# CITY OF ALBUQUERQUE

**RE: 9414 Susan Avenue SE  
Grading & Drainage Plan  
Engineer's Stamp Date: 4/3/25  
Hydrology File: L20D080  
Case # HYDR-2025-00181**

Based upon the information provided in your submittal received 5/19/2025, the Grading & Drainage Plan is **approved** for Building Permit and Grading Permit. Please attach a copy of this approved plan in the construction sets for Building Permit processing along with a copy of this letter.

**GRADING & DRAINAGE PLAN**

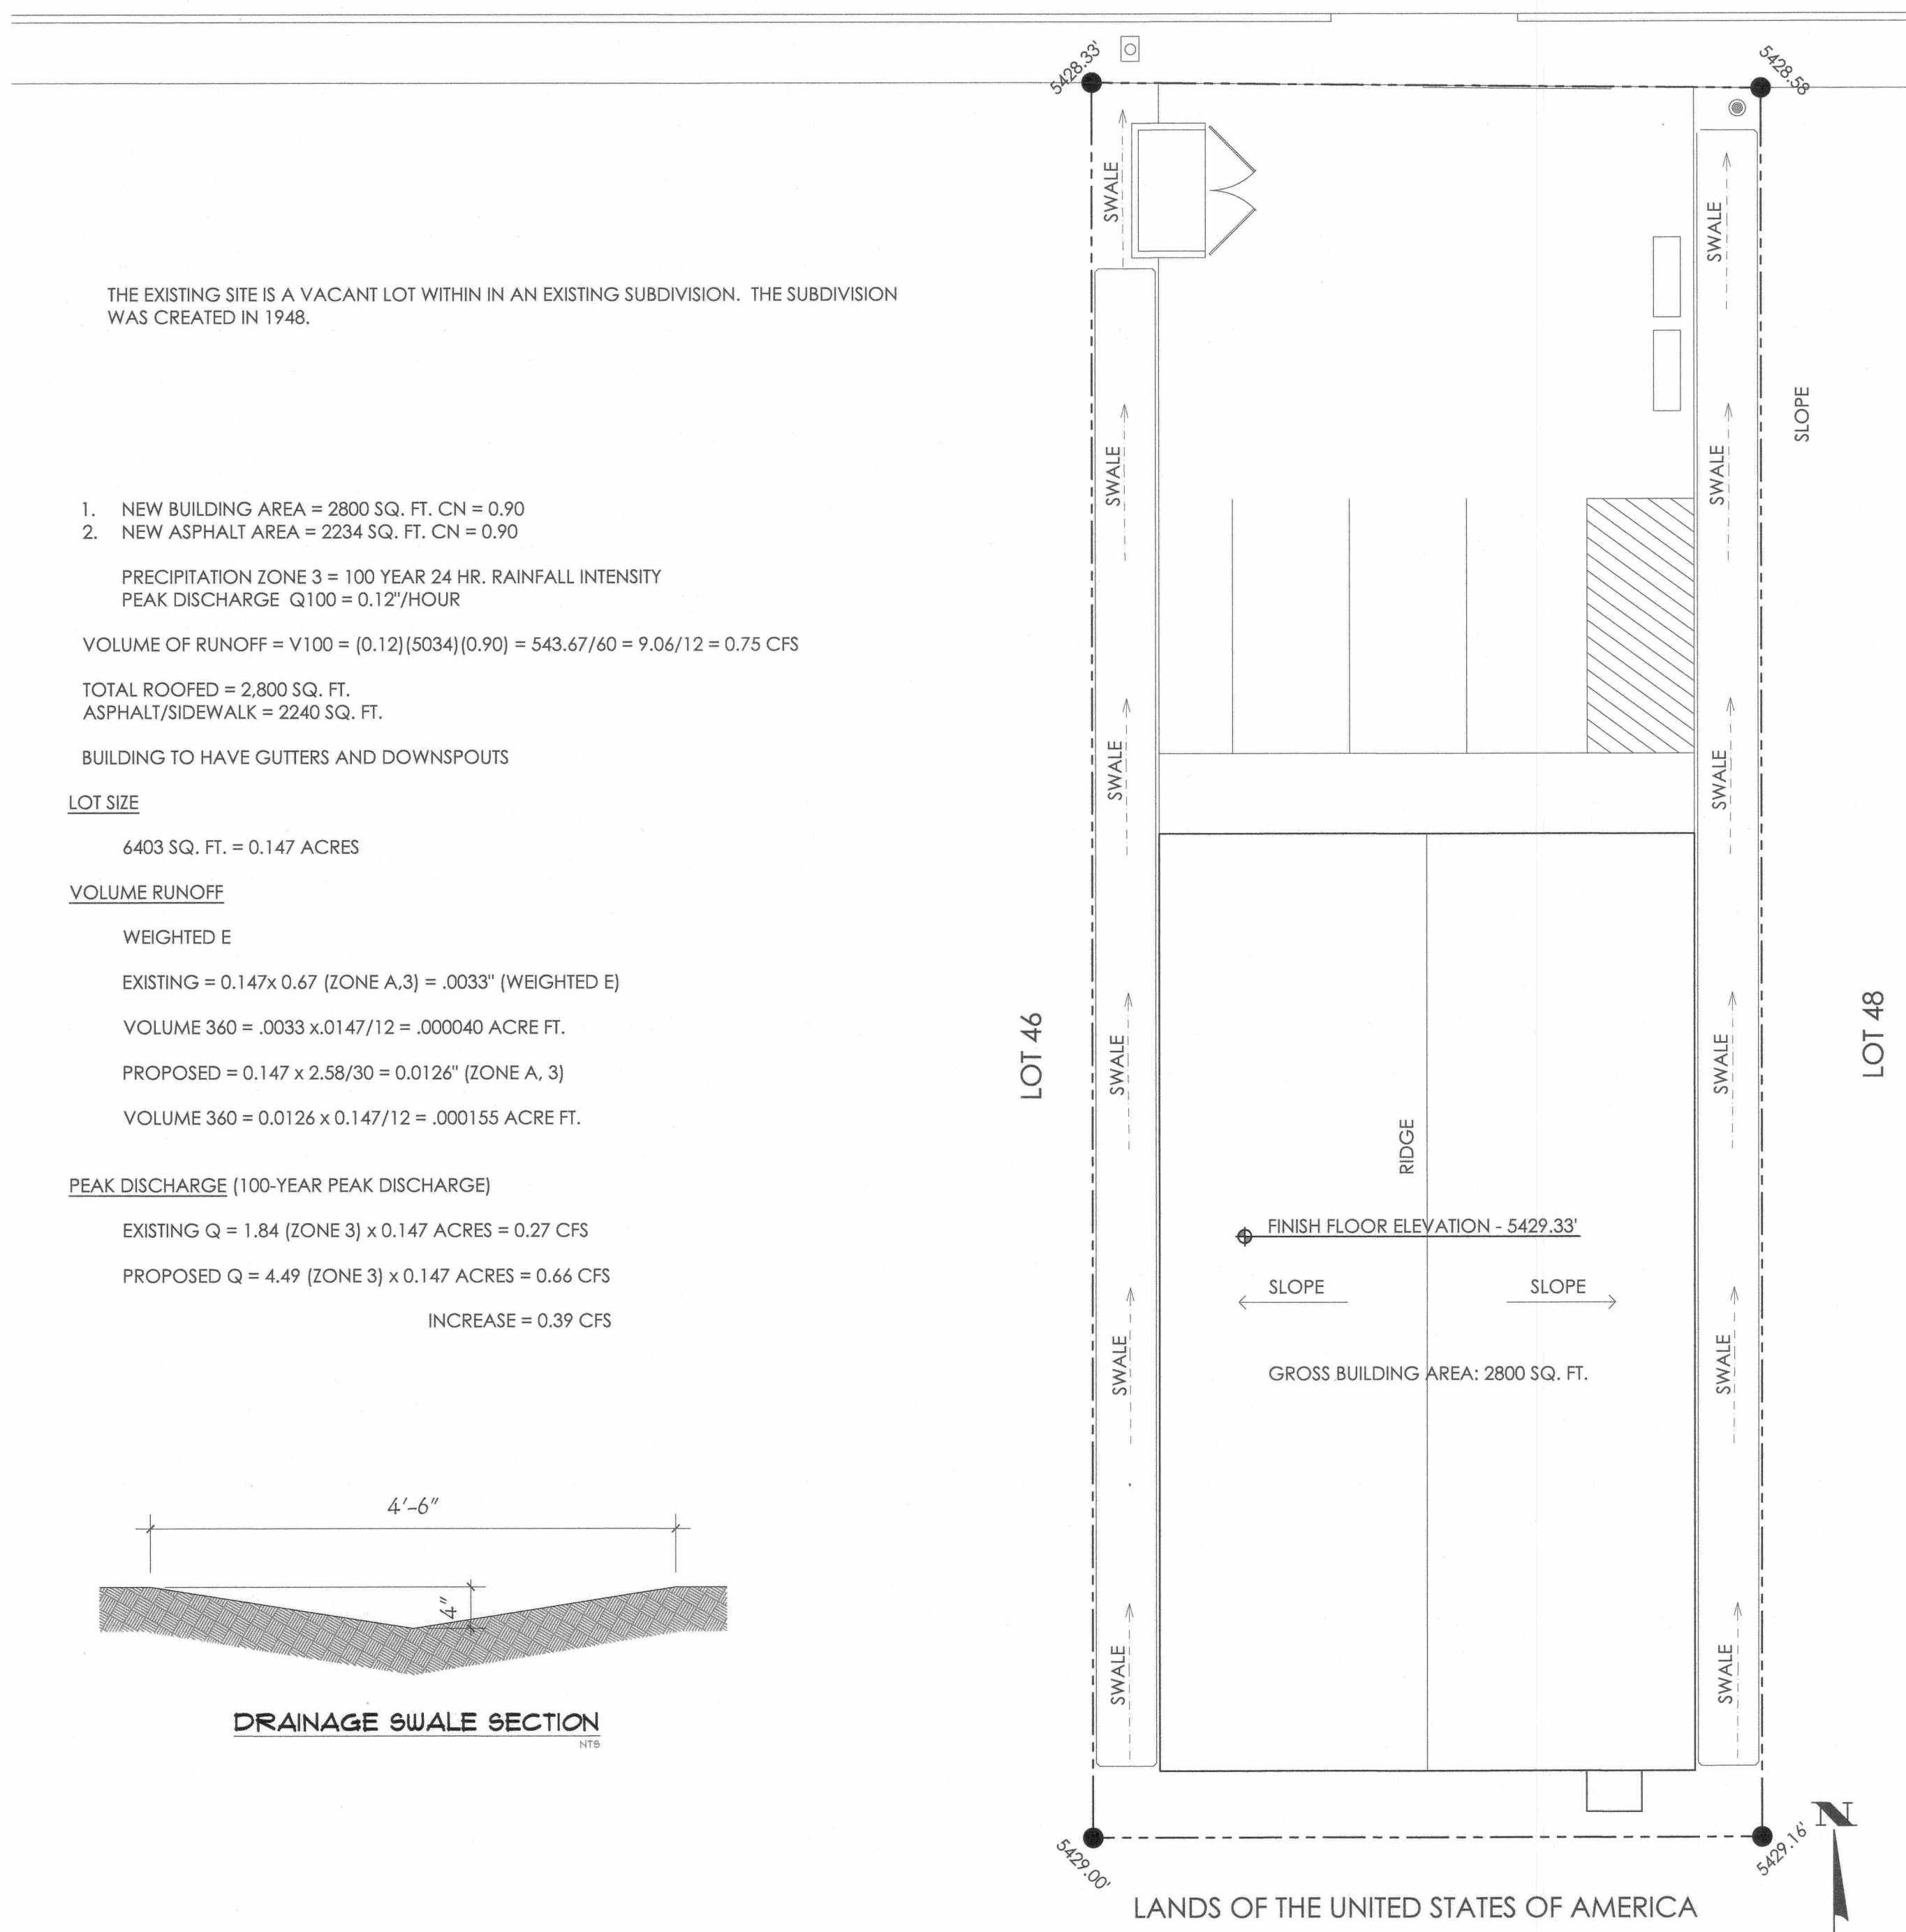
1. Engineer's Certification, per the DPM Part 6-14 (F): Engineer's Certification Checklist For Non-Subdivision is required.
